SSD7348 MOD 10, OAKDALE WEST STAGE – S.4.55(1A) APPLICATION TO MODIFY ARCHITECTURE PLANS

As the consent authority for SSD7348, the Department of Planning, Industry and Environment (DPIE) are authorised to modify the consent provided the above is met. This is the **tenth (10)** modification to SSD7348 and seeks to:

Appendix A – Updated Masterplan and Lot 1A plans

Figure 1 – approved Precinct 5 layout

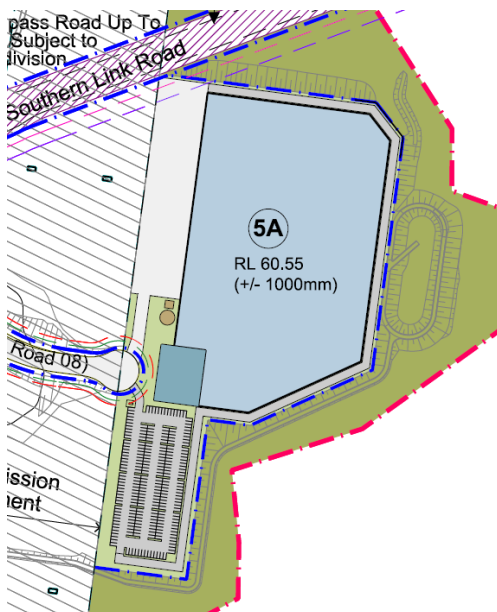
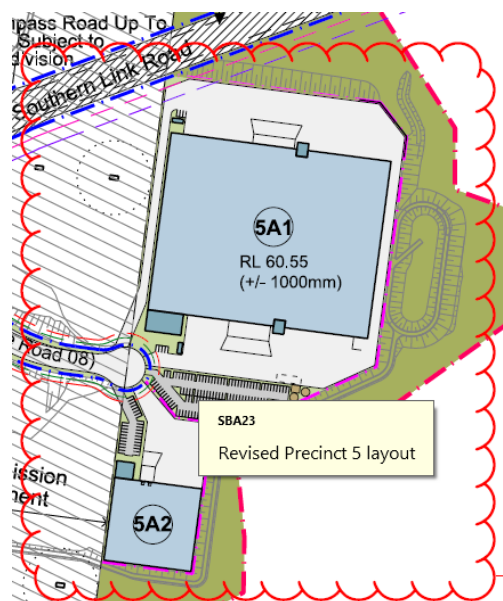
- Reduce the size of primary warehouse, shown as warehouse 5A in approved concept plan) and the addition of a new small warehouse (Warehouse 5A2).
- This layout update is to reflect customer demand.
- The update results in a reduced Precinct 5 car parking from 245 spaces to 137 spaces.
- The update results in a GFA reduction from 35,640sqm to 32,325sqm.
- It's noted Precinct 5 is subject to separate Penrith Council DA assessment, to be lodged imminently.
- The layout update is required to ensure consistency between the SSD7348 masterplan and development at Precinct 5

Figure 2 – Approved Sign D & E

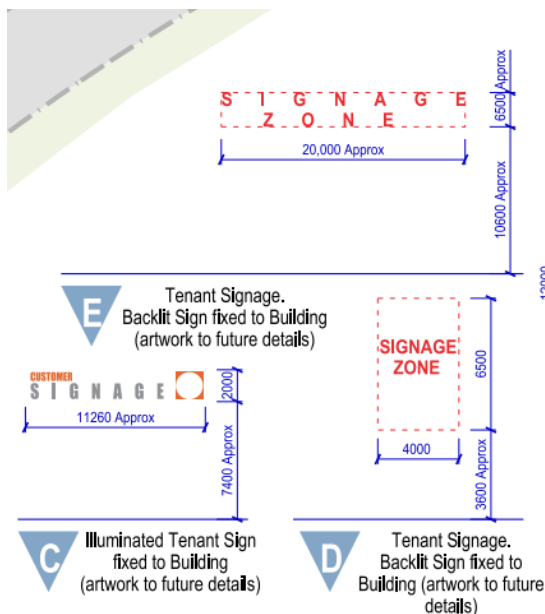
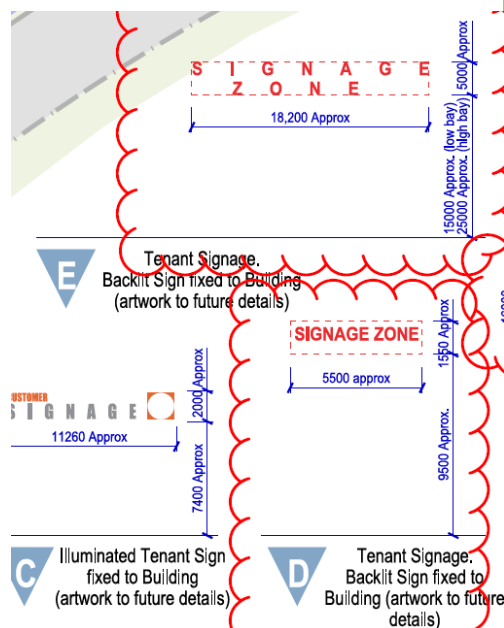
- 1) Pylon Sign (S1) sought for height increase from 16m to 16m height:
 - The proposed 16m height is considered more appropriately scaled considering the context, particularly the significant 36m adjacent Lot 1A warehouse.
 - The location of the S1 sign proposed to remain as approved.
 - The reason for the update is that the 16m sign would be too recessive considering the estate context.
- 2) Tenant façade signage “D” and “E” reduced in size as per customer request – refer **Fig.2**

- 3) Sign "E" removed from south east corner office of warehouse 1A
